RE: **Approval of Plans (REV 1)**
TDOT Gibson County Maintenance Building
1248 B Manufacturers Row
Trenton, TN 38382

TFM # 21267
Project # 2023-11-09-02
County: Gibson

Revision #1 Drawing Changes

4 FIRST FLOOR PLAN - WASTE AND VENT

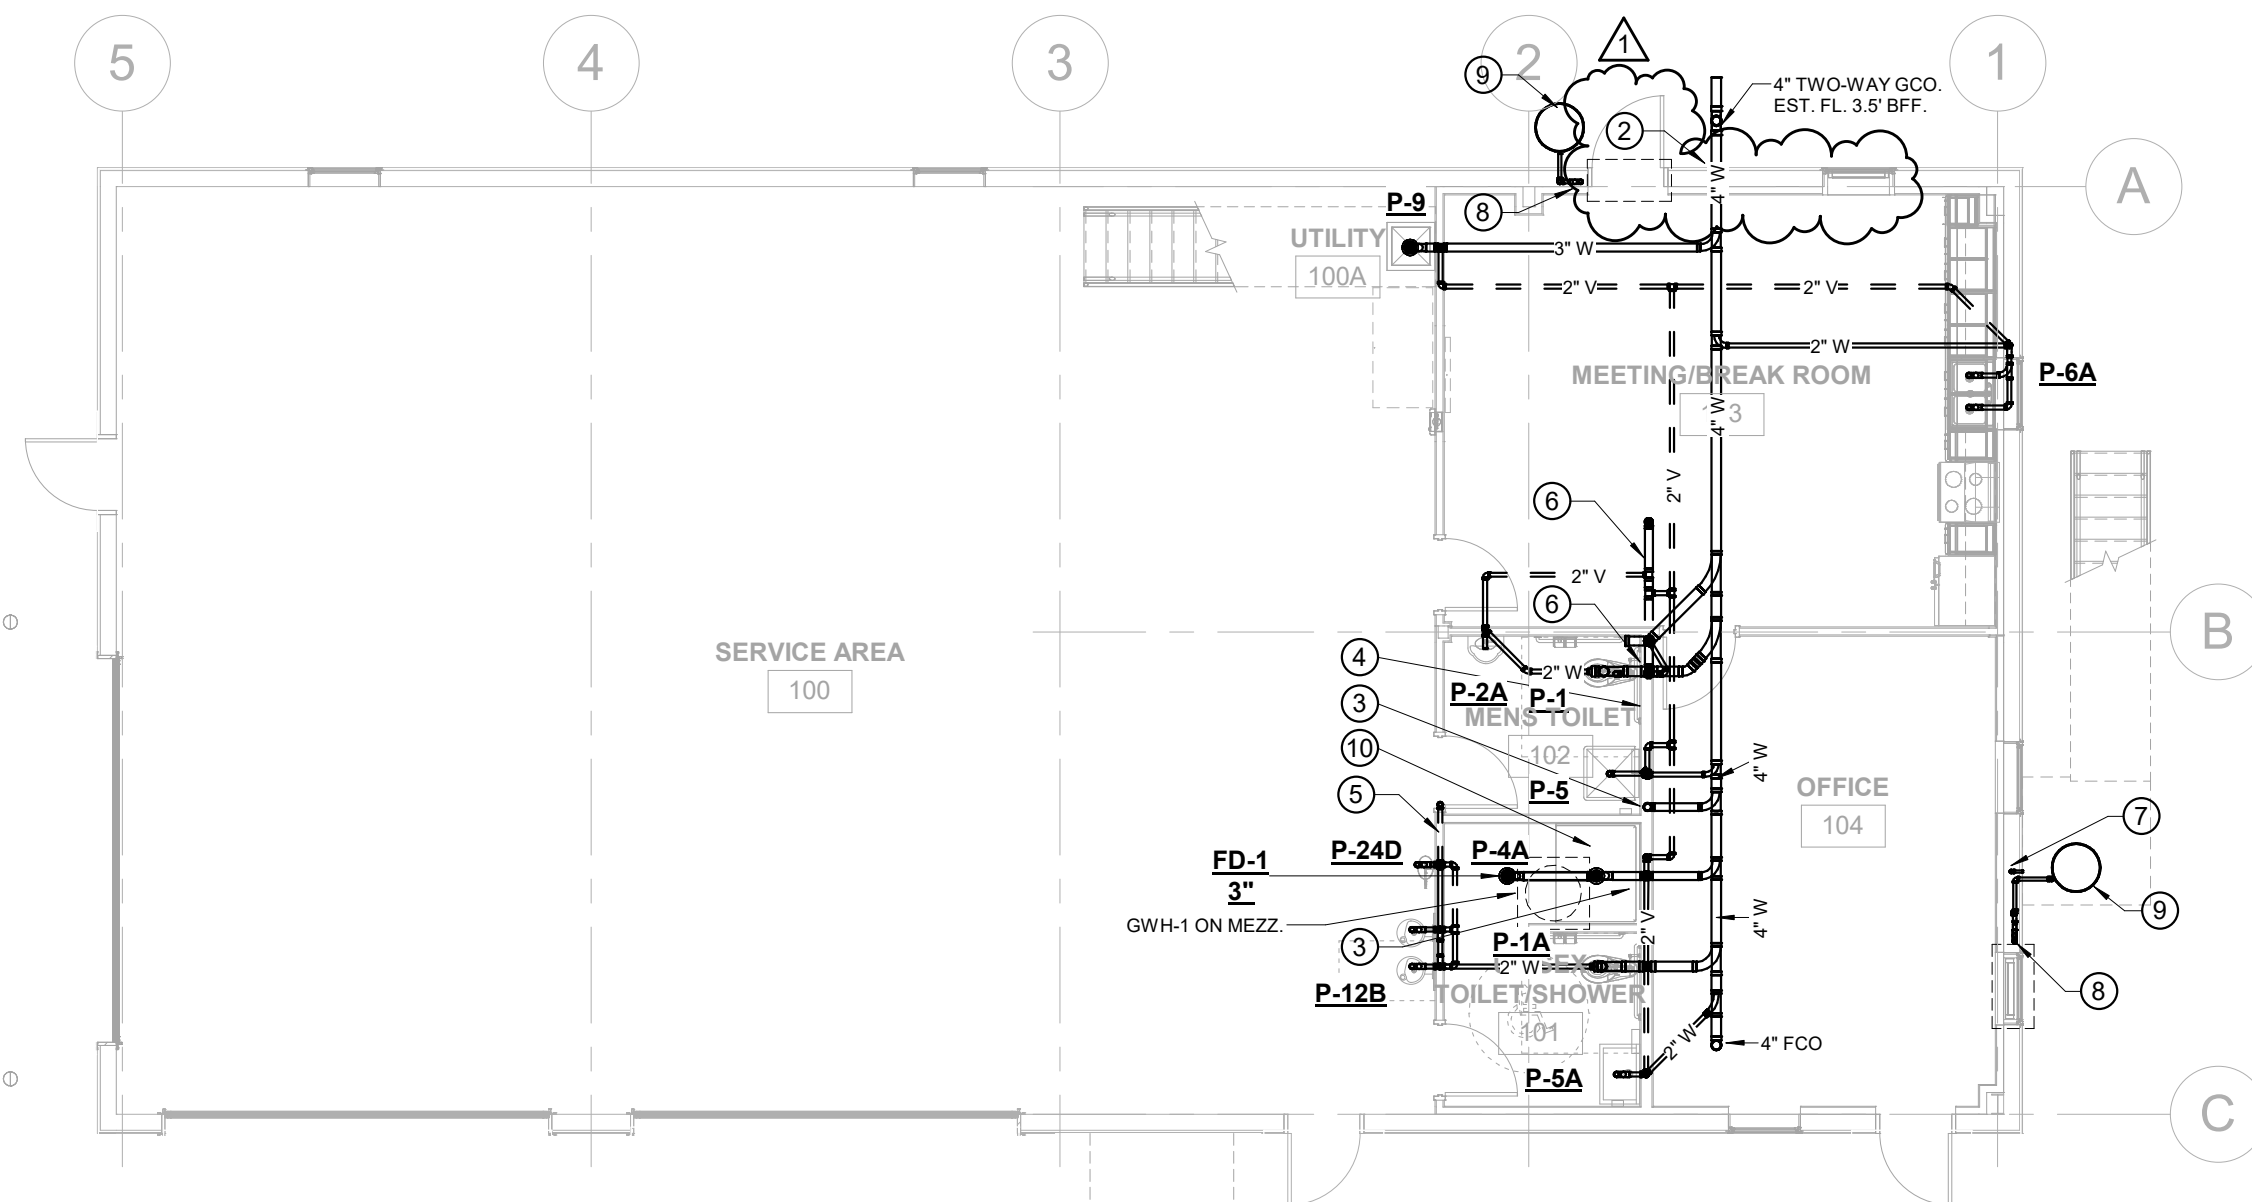
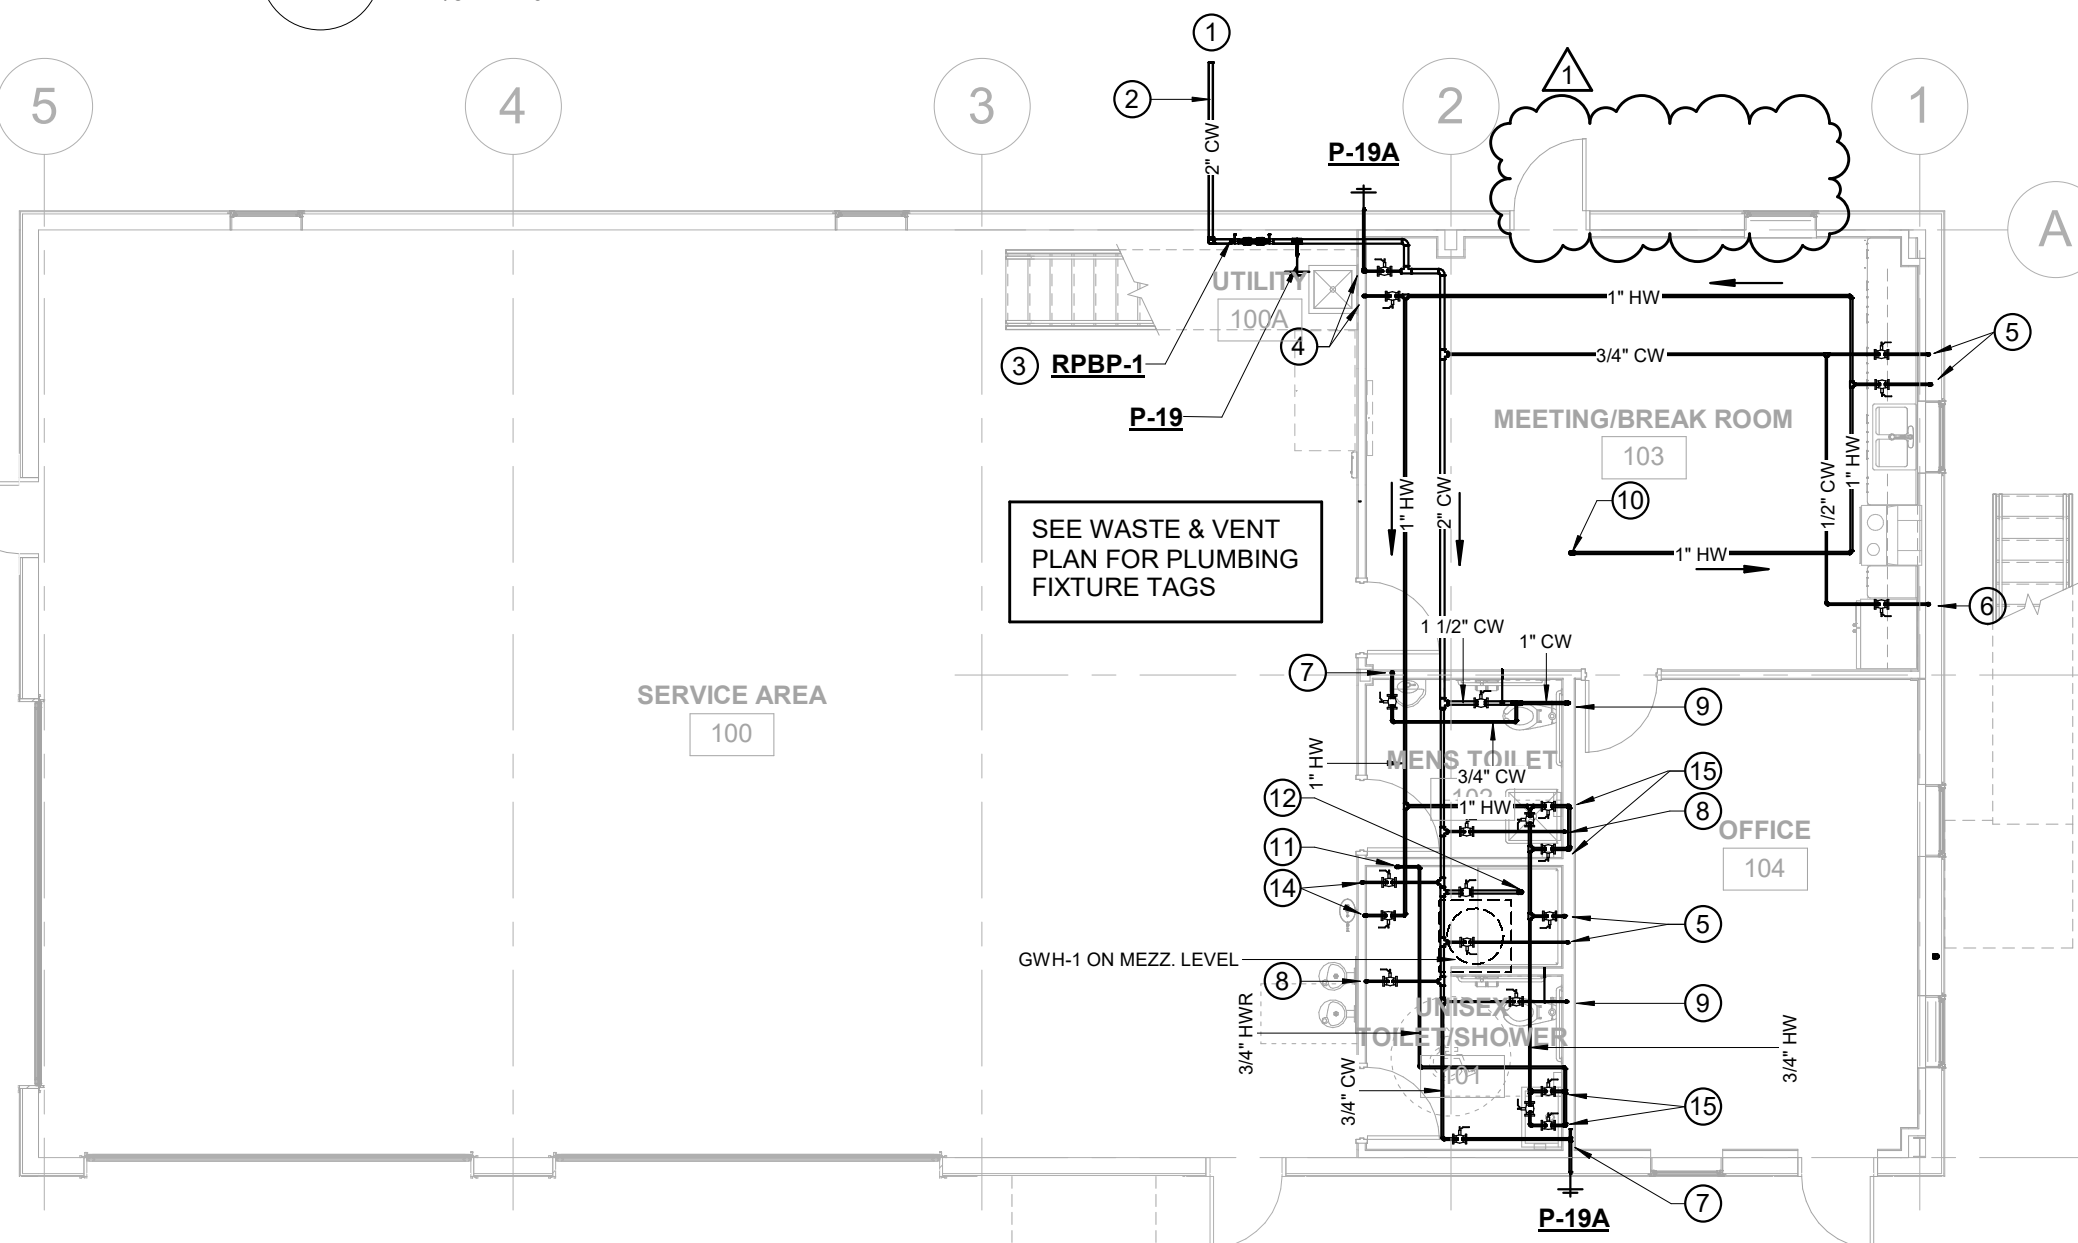
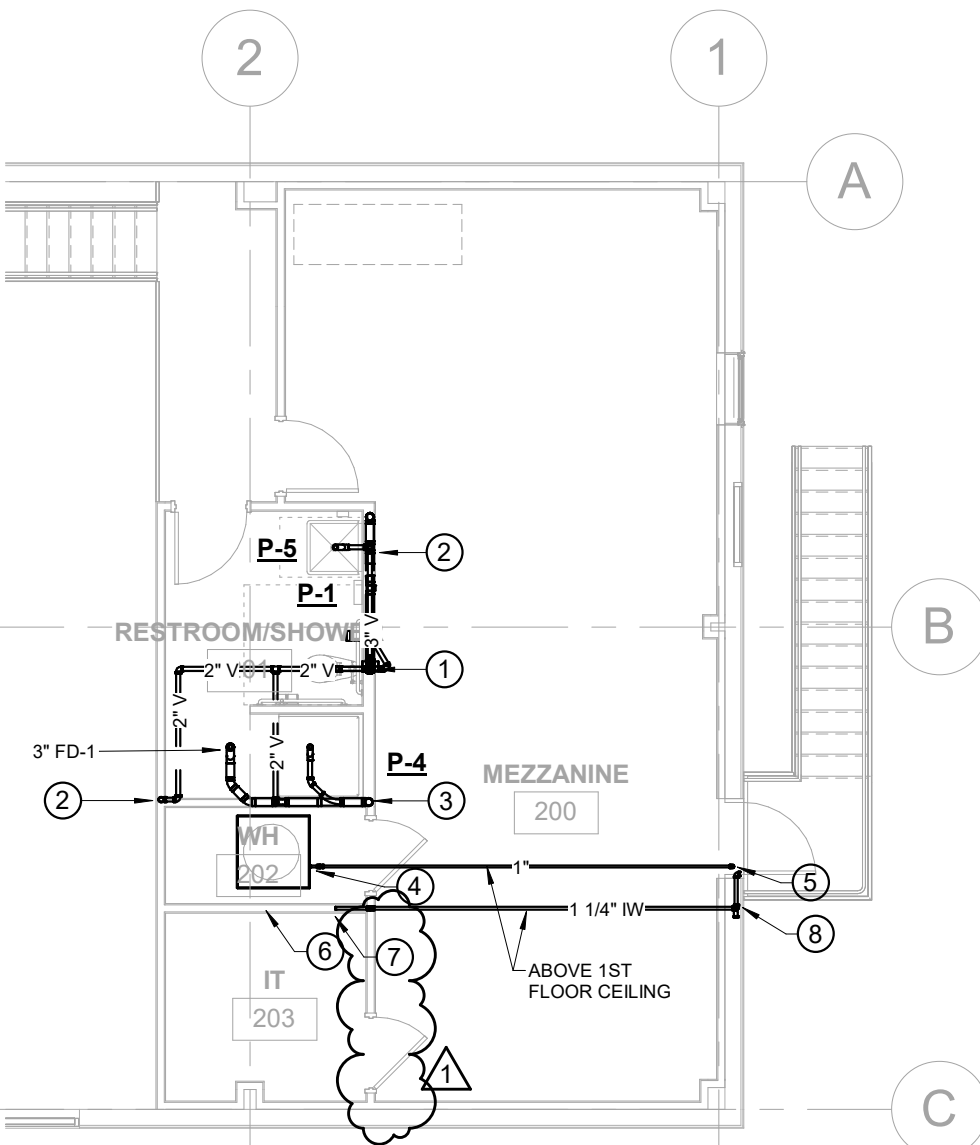
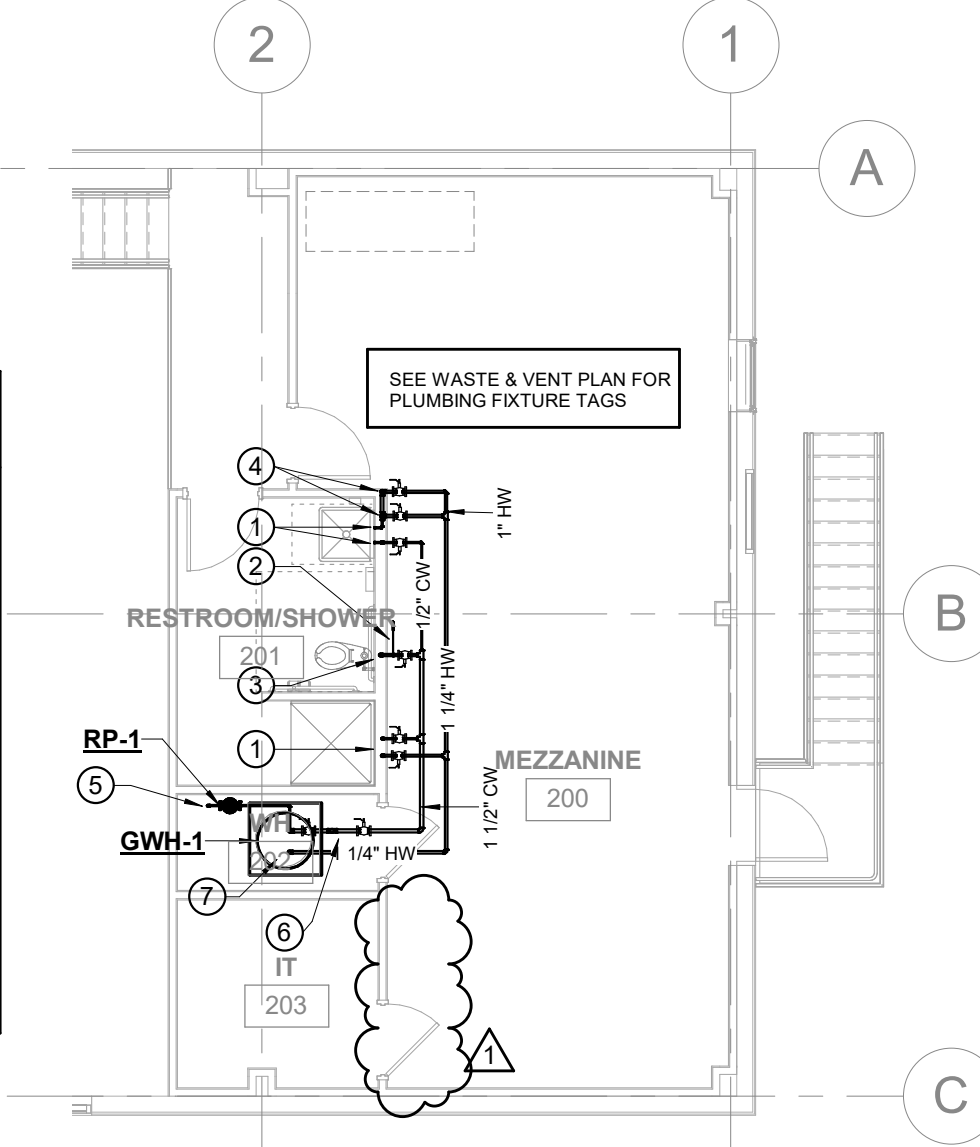
Sheet P1.1: Revised location of exterior door, revised location of door to IT room.

ELECTRICAL
CORE AND
SHELL
E1.0

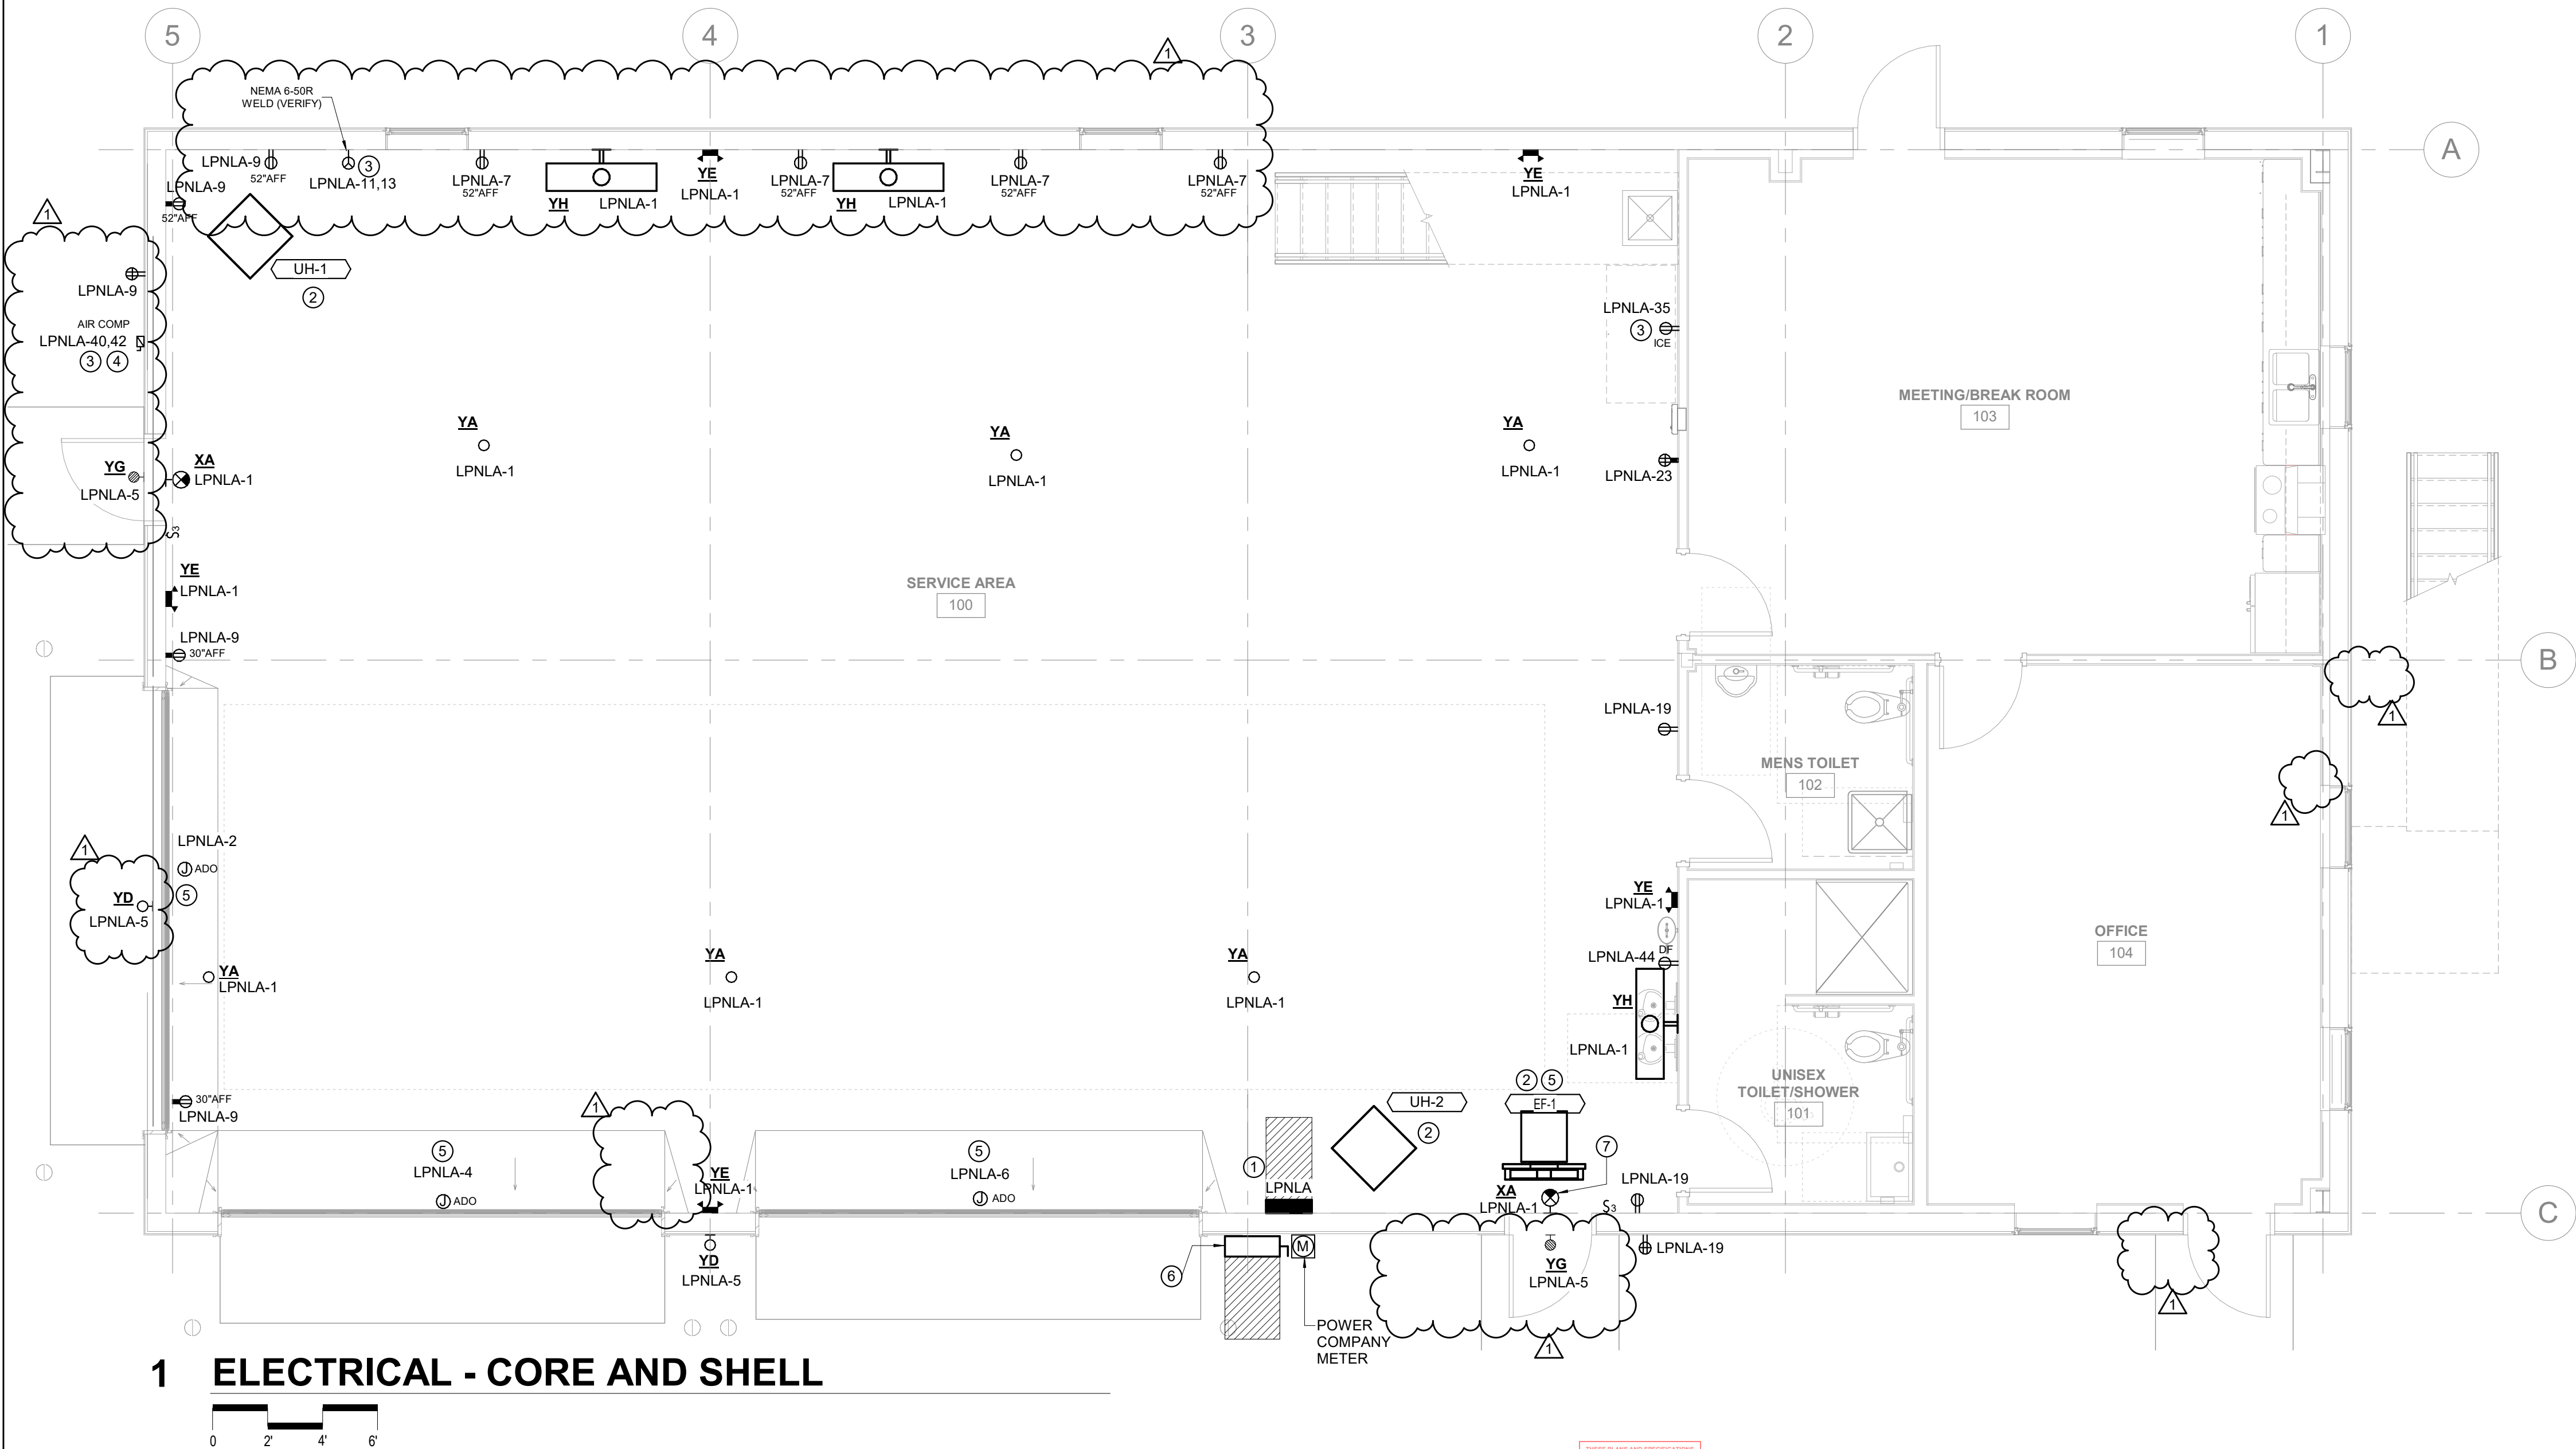
Sheet E1.0: Added lights and 52" high receptacles along plan north wall of the shop area, power for air compressor was moved to plan northwest corner and maintenance receptacle was added, type YG light on plan west was moved over man door, type YD light on plan west wall was moved over garage door, special configuration receptacle was moved from plan south wall to plan northwest corner, type YG light on plan south wall was moved over man door, redundant electrical and lighting fixtures that are already shown on E1.1 were removed from the office area.
